TOWN OF MILFORD, NH
OFFICE OF COMMUNITY DEVELOPMENT

Date: September 15, 2022
To: Planning Board
From: Camille Pattison, NRPC Assistant Director
Subject: SP2022-08 Sooner Transportation LLC, for the property located at Tax Map 12, Lot 11, 754-756 Elm Street (Horseless Carriage Site). Public Hearing for a Major Site Plan Application to construct a two-story, 10,320 sf. auto sales and repair facility with associated parking, stormwater management/drainage, landscaping, and lighting improvements on the subject property located in the Commercial 'C' Zoning District and West Elm Overlay District.

Re: September 20th Planning Board Meeting Discussion
Sooner Milford Site Plan
754-756 Elm St
Map 12 Lot 11

Example No. 1

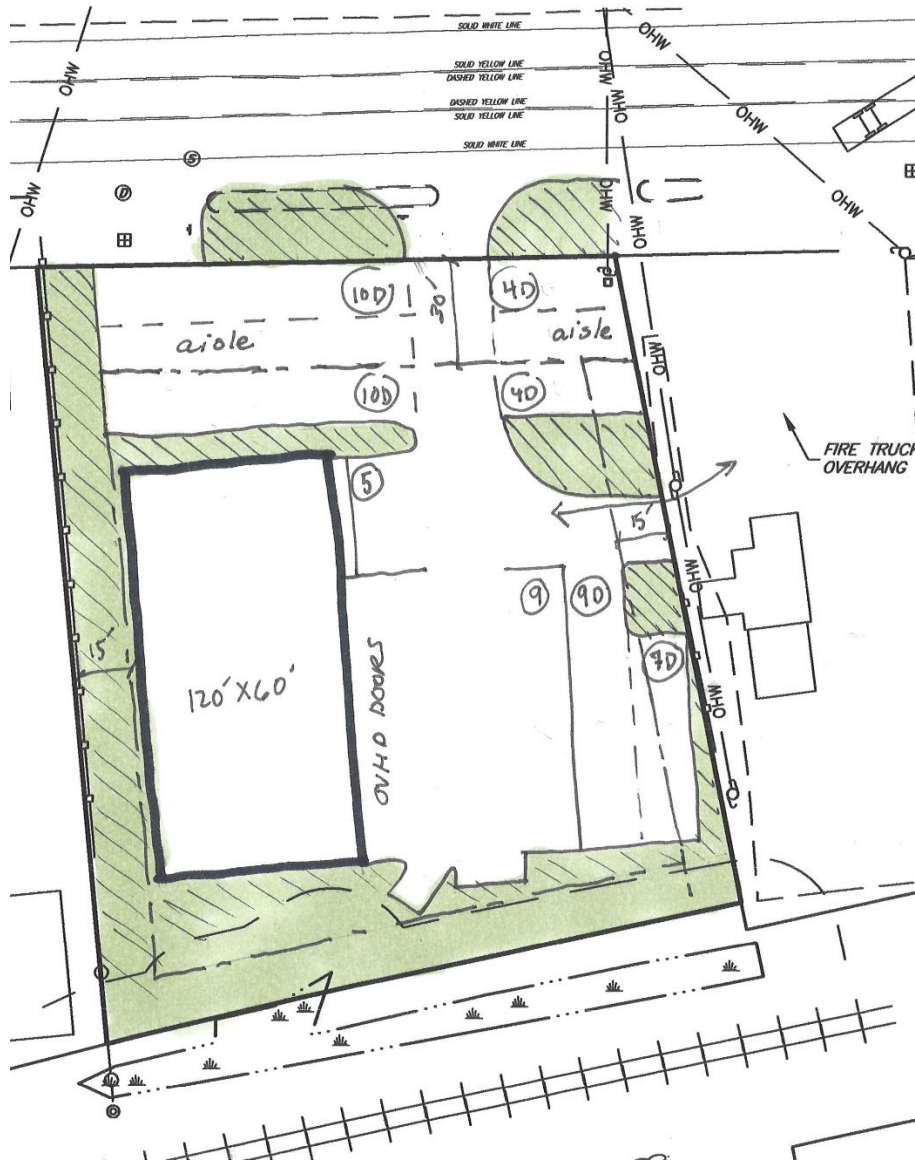
In example No. 1 we show the building at the front setback line with parking out back. This is the prescribed Overlay district scenario with green space out front, the building close the street, and parking

BUILDING DISTANCES TO CURB LINE

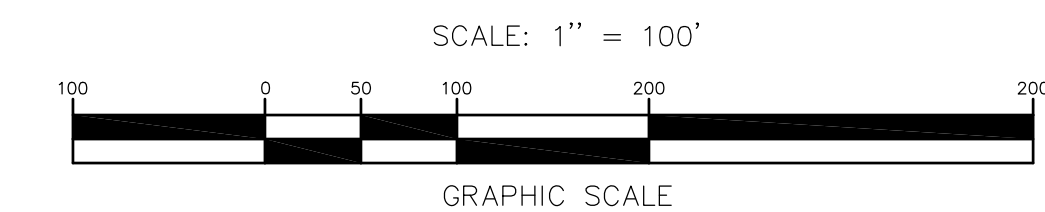
We have also included a Building Dimension Exhibit showing the distance from the street curb to all the buildings on this section of Route 101. The average distance from curb to building (see calculations on the attached plan) is 82' for the 13 buildings. Our proposed building is 145' from the curb line. There are

TAX MAP 12 LOT 11
OVERVIEW & SITE PLAN
SOONER-MILFORD
 LOCATED AT:
754-756 ELM STREET
MILFORD, NEW HAMPSHIRE, 03055
 OWNER: LAND BARGE, LLC
 APPLICANT: SOONER TRANSPORTATION LLC
 754-756 ELM STREET
 3 EXECUTIVE PARK DRIVE, SUITE 2016
 MILFORD, NH 03055
 BEDFORD, NH 03110

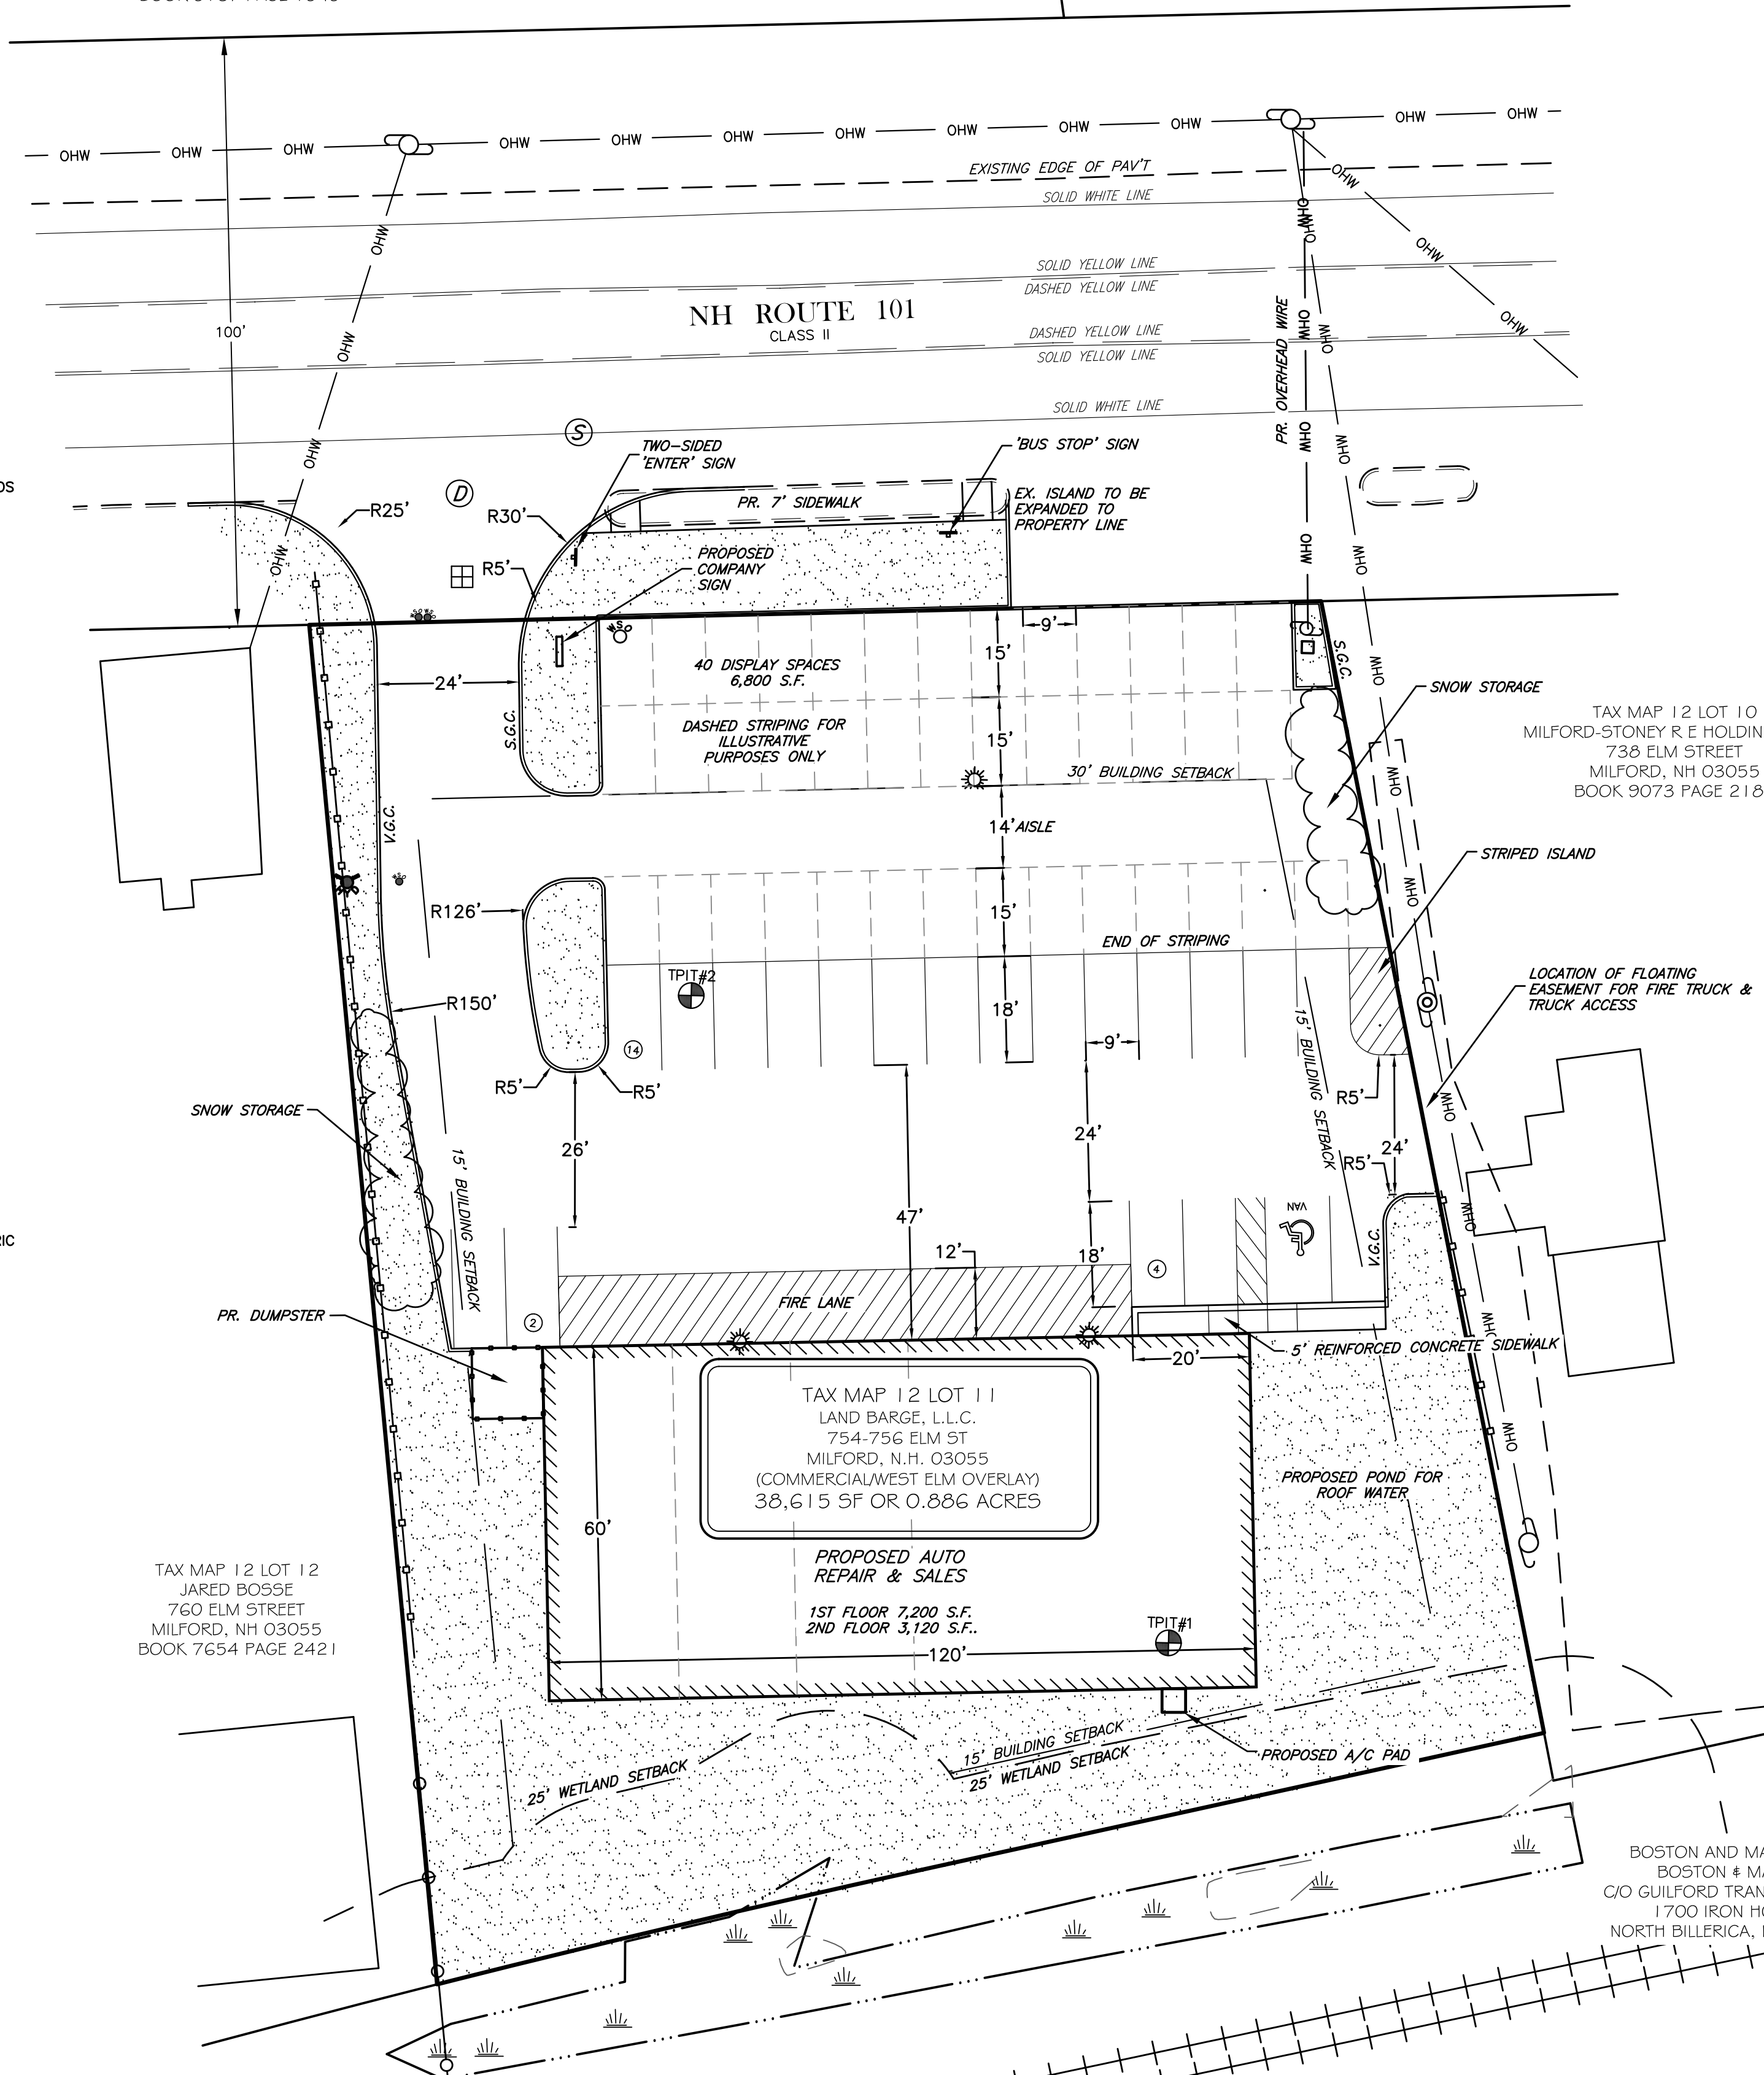
8. Sheet 1, Note 8 – Please update the site plan to include the existing and resulting open space calculations in the *Dimensional Regulations: Commercial* table.

9. Please revise site plan to include all proposed signage for the project.
10. Sheets 1 and 10 – The site plan shows the proposed location of the dumpster and pad encircled by an 8’ stockade fence within the 15 foot westerly side dimensional setback. The proposed 8’ stockade fence and concrete pad are defined as structures in the Town’s Zoning Ordinance and such, would require a Special Exception by the Board of Adjustment for relief of this requirement. The alternative would be amend the plan and relocate the dumpster outside of the dimensional setback.

11. Sheet 1 – The plan displays a 12’ wide loading area within the state owned right of way. The proposal may effect and impact the traffic conditions on Elm Street and abutting properties. Further as stated in Section 6.05.6.E, all off-street parking and loading or unloading spaces shall be at least ten feet (10’) from any public street right-of-way and shall be separated from such right-of-way by a granite curb and landscaping as required in 6.08 LANDSCAPING STANDARDS. The proposal require a waiver of these requirements and require NHDOT approval and dedicated easement to use the area within the right of way.

12. Sheet 1 – The plan shows display parking space partially located off the property and within the State right-of-way. As stated in the Zoning Ordinance, Section 6.05.6.E, Parking and loading spaces shall be arranged so that cars will not back into public roads. The plan will need to amended to relocate said parking spaces within the subject property at least 10 feet from the Elm Street public right-of-way.

13. Sheet 1 - The applicant should be explain the internal circulation, access/egress patterns for the 46+ display vehicles. At a minimum, the plan should be revised to include the appropriate isle widths between the rows of display vehicle parking.

14. Sheet 1 – Staff questions if the adequate snow storage areas have been provided. A note should be added to the plan stating that snow shall be removed to an offsite location using best management practices.

TAX MAP 12 LOT 11
GRADING & UTILITIES PLAN
SOONER-MILFORD
 LOCATED AT:
754-756 ELM STREET
MILFORD, NEW HAMPSHIRE, 03055

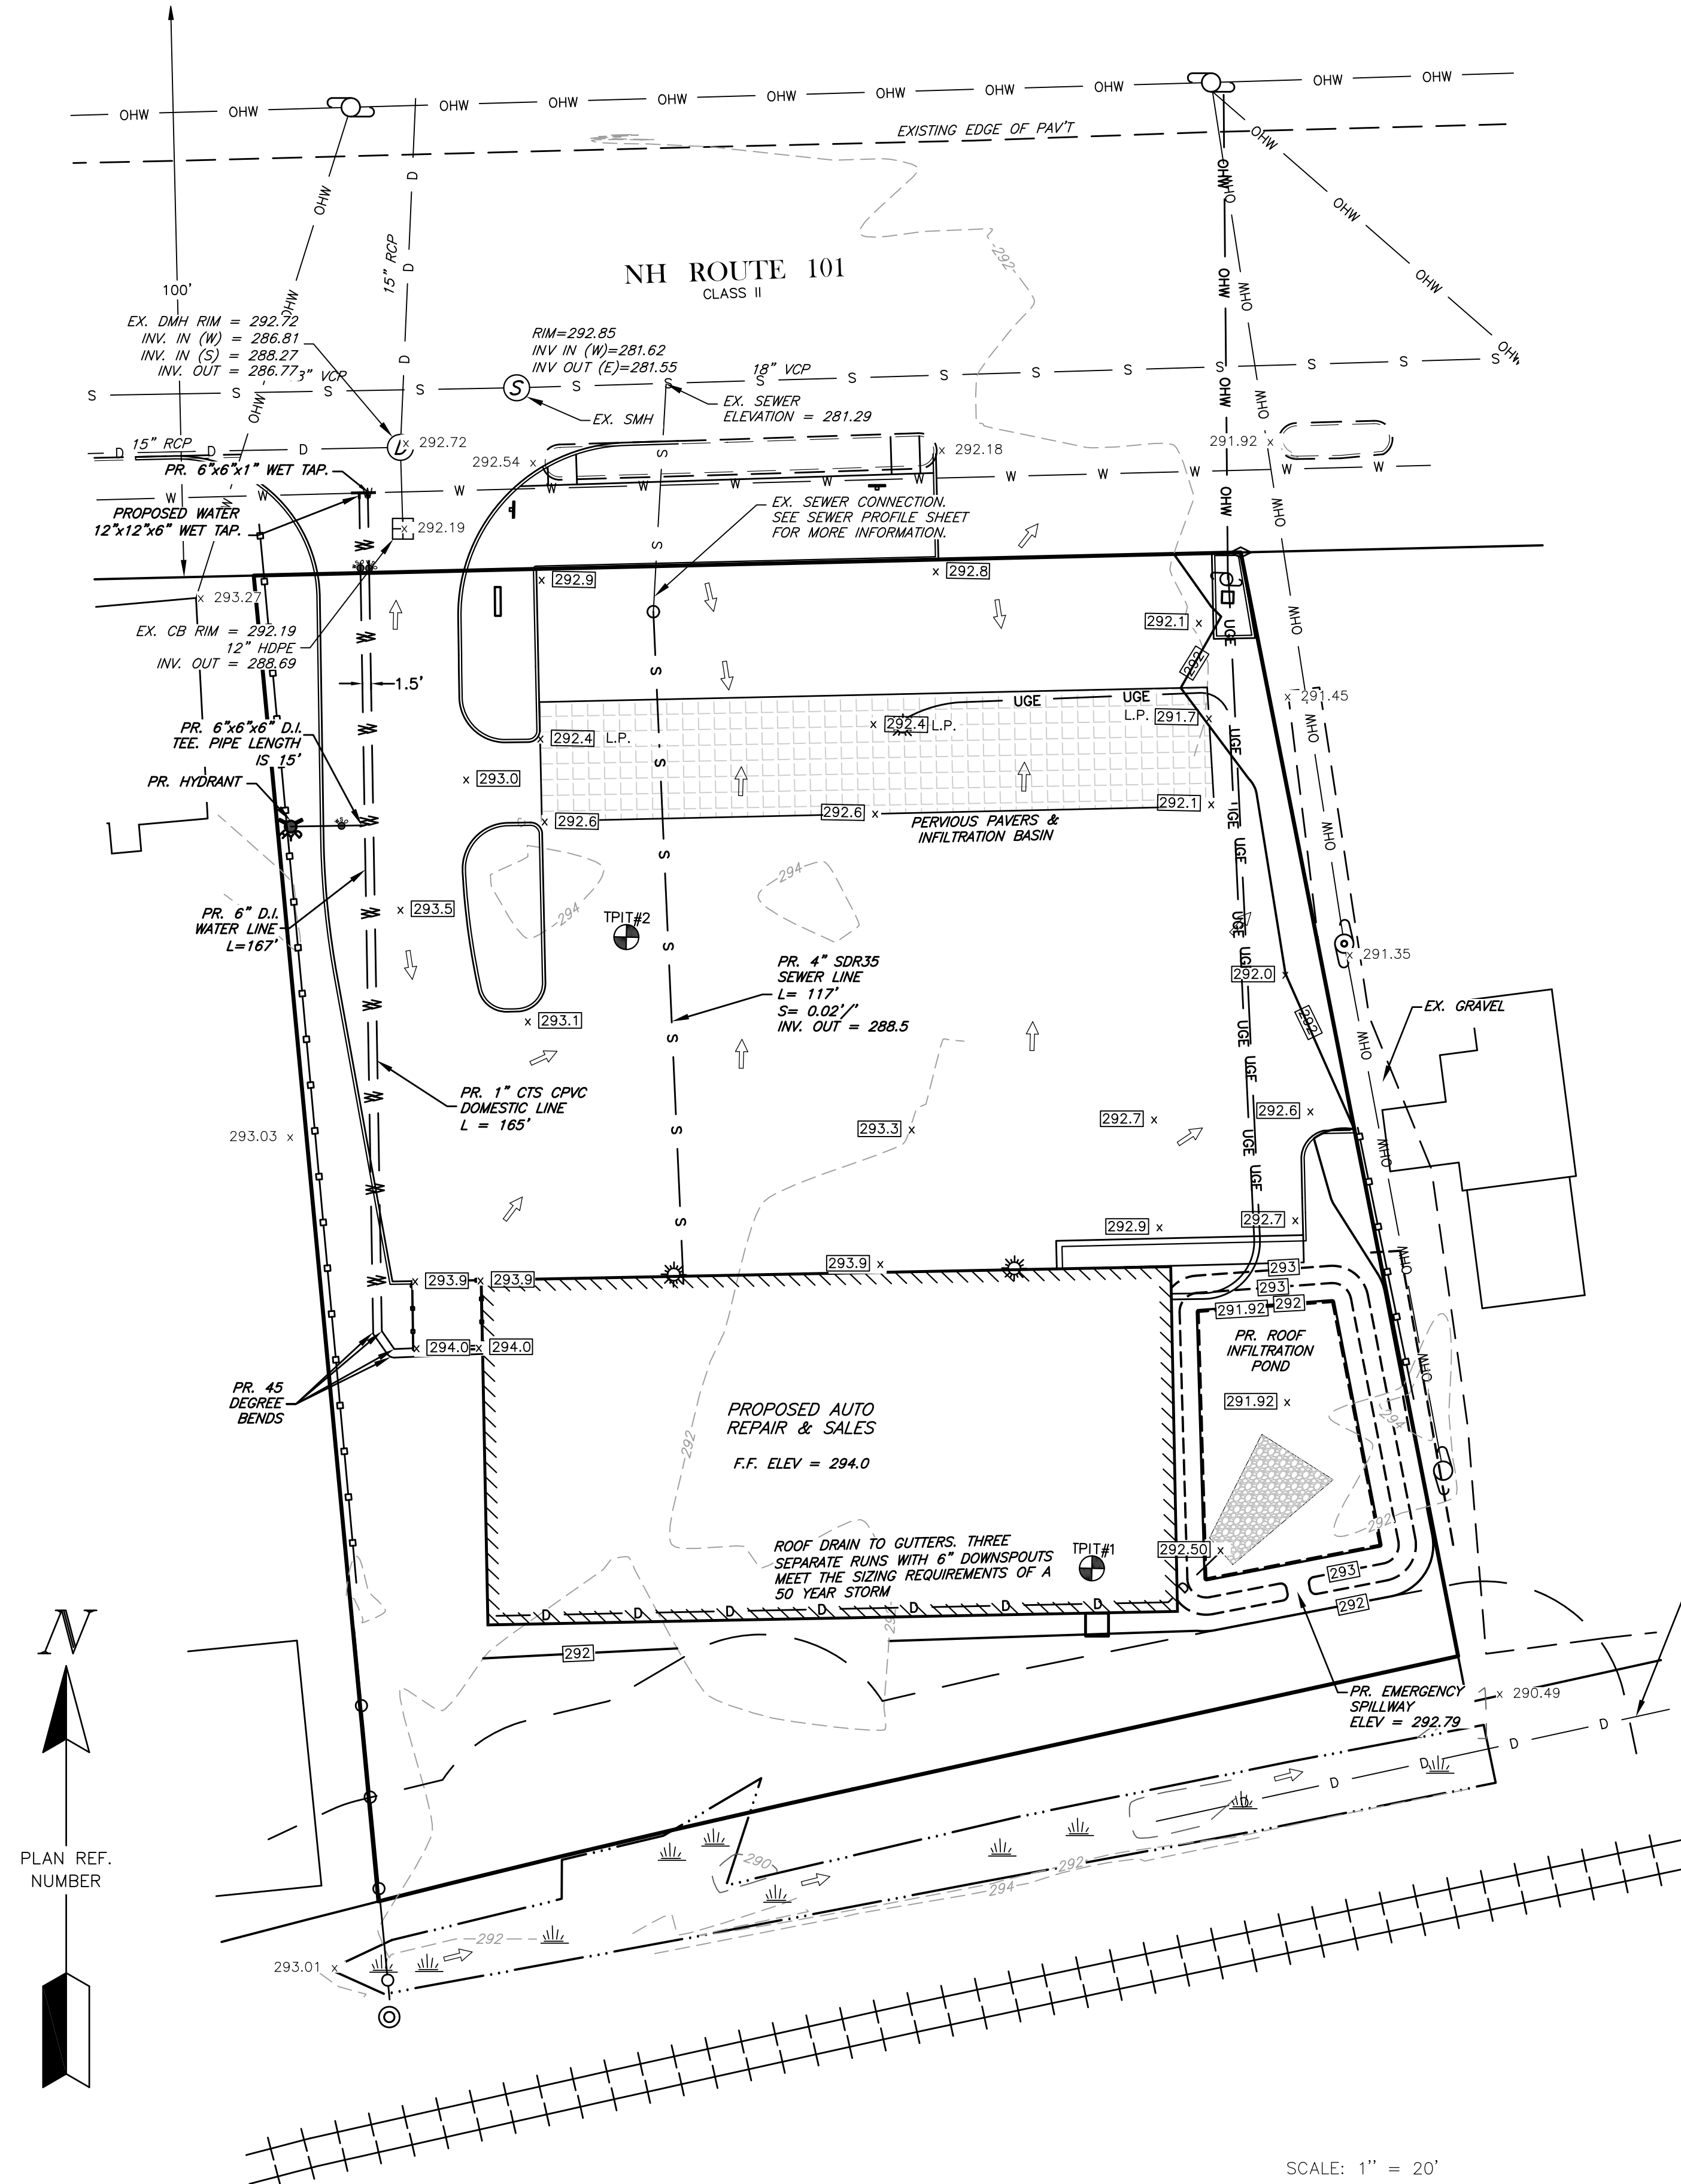
5. An automatic sprinkler system is required for this building. I did note a proposed 6" fire service on the grading and utility plan, so I'm assuming that they're planning on providing one.

1. The service needs to be from the main in the street, not stubbed off the fire line. The domestic should be 1 inch CTS running 18 inches from the 6-inch fire line. Please revise plan accordingly.
2. The Sewer once it reaches the Town right of way must turn from 4 inch to 6-inch SDR 35. Please revise plan accordingly.
3. The Water line out in the road is a 12 inch, not 8 inches. Please revise plan accordingly.
